SITE PLAN CHECKLIST

| HOH WAREHOUSE<br>SITE & LANDSCAPING PLAN                                                       |                                |
| LOT 4, BLOCK 6, BAKKER LANDING 1ST ADDITION<br>TEA, SD 57064                                   |                                |
| SHEET NO.<br>C-104                                                                             |                                |

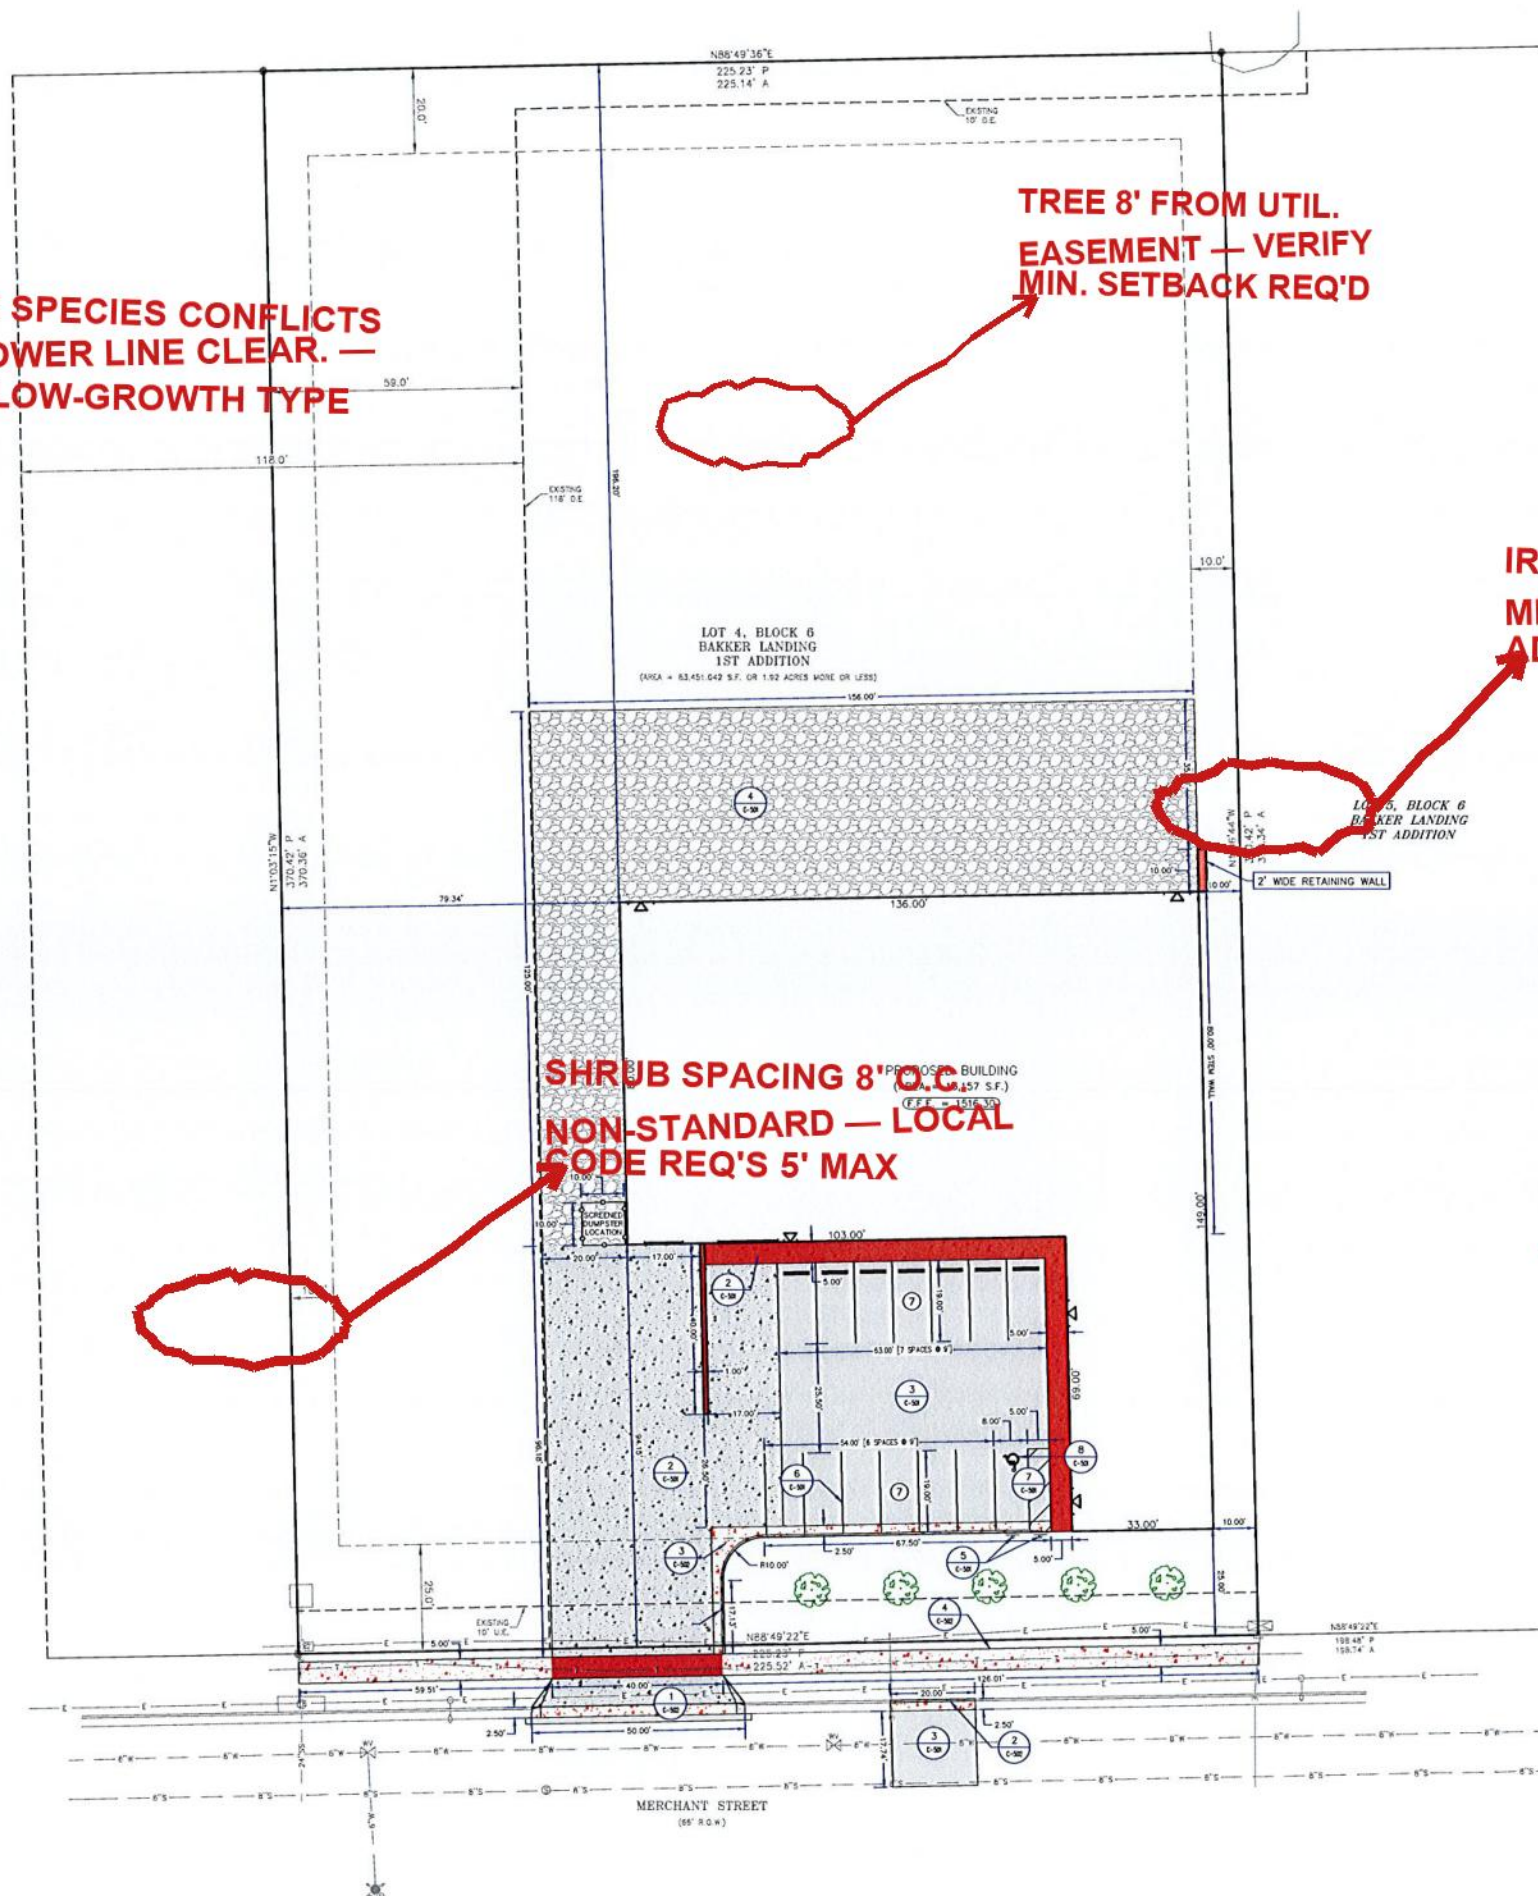
TREE SPECIES CONFLICTS  
W/ POWER LINE CLEAR. —  
USE LOW-GROWTH TYPE

TREE 8' FROM UTIL.  
EASEMENT — VERIFY  
MIN. SETBACK REQ'D

IRRIGATION COVERAGE  
MISSING AT E CORNER —  
ADD ZONE OR HEADS

SHRUB SPACING 8' O.C.  
NON-STANDARD — LOCAL  
CODE REQ'S 5' MAX

GROUND COVER TYPE  
NOT SPECIFIED AT  
BORE HOLE LOCATION AREA

??
